MEMORANDUM

DATE: February 2, 2015

TO: SJRIP Biology Committee

FROM: Brian Westfall & Ron Bliesner

Revised San Juan River Basin Model Rule Decision Tree

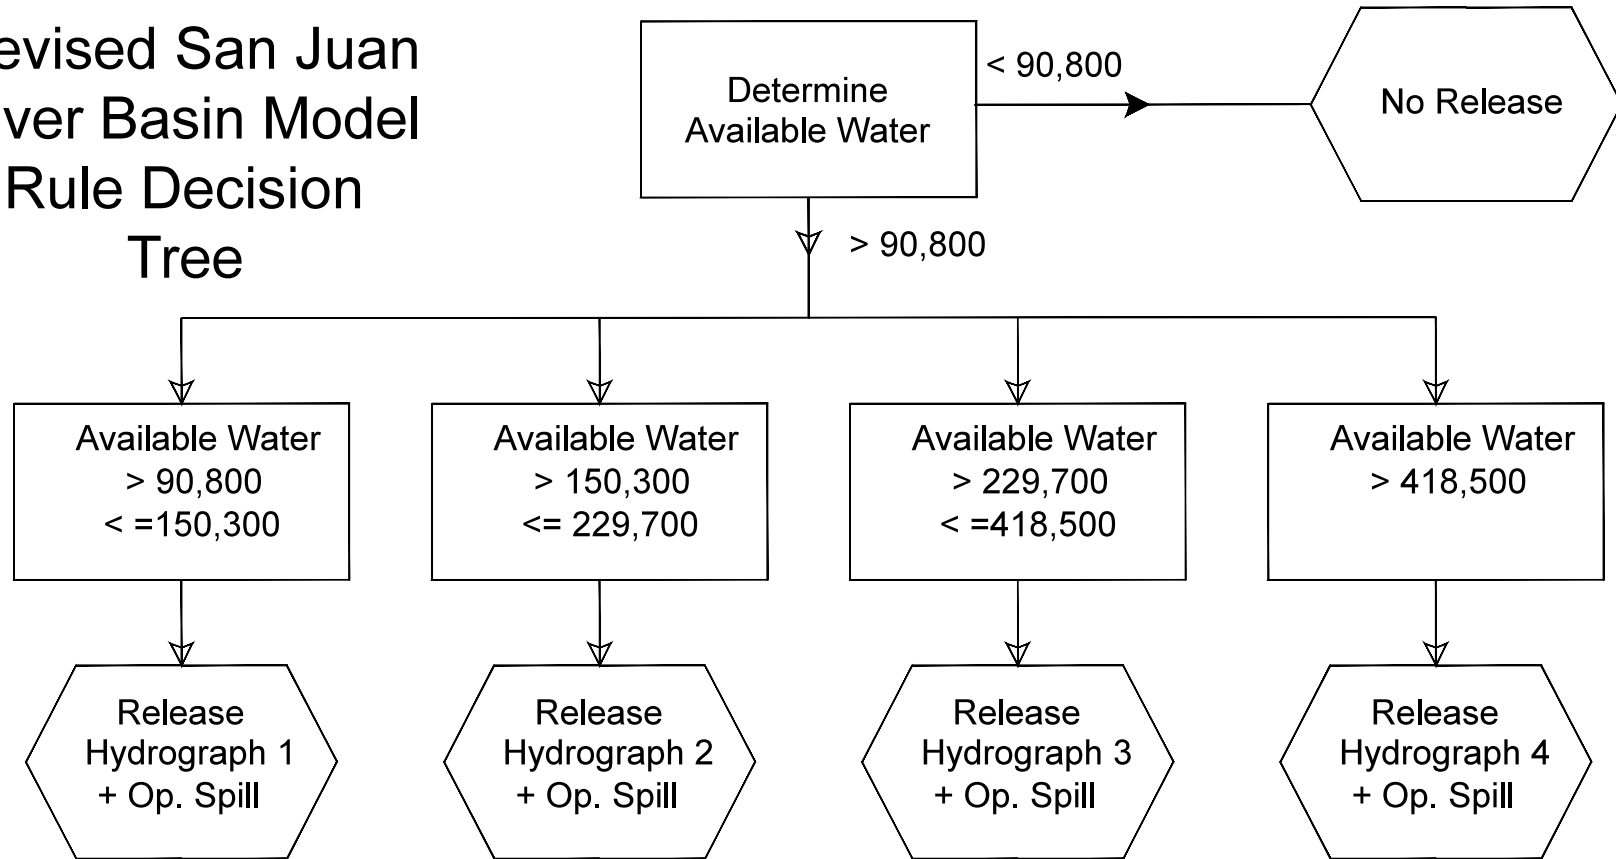
Attached is our interpretation of the decision tree that Reclamation is proposing to implement. It is a significant change to the flow recommendation in that there is no consideration of previous year releases in making the current year release. The selected spring peak hydrographs in the attached decision tree are based on the existing flow recommendations. The volumes are somewhat different than those in the existing decision tree because of the ramps (ramp up to and down from 5000 cfs) and the inclusion of base flow. The 1999 Flow Recommendation spring peak release volumes excluded base flow in the computation, computing the volume on top of the base flow. The resulting releases include more years without any release and fewer small releases. The 2005 flow recommendation evaluation found these smaller releases to be ineffective and recommended adjusting the decision tree to remove the focus on these small releases to allow an increase in the frequency of the larger releases. The Reclamation proposal, while not directed at this change, results in the same outcome.

Reclamation is also proposing a change in how operational spills are managed. The flow recommendations suggest maintaining 500 cfs from Farmington to Lake Powell. Operational spill was to be released in the fall as a spike release. Reclamation's current suggested operation is to first increase target base flows during the summer and make a fall spike release if necessary to achieve the EOYWST. The biological implications of this change should be discussed prior to implementation.
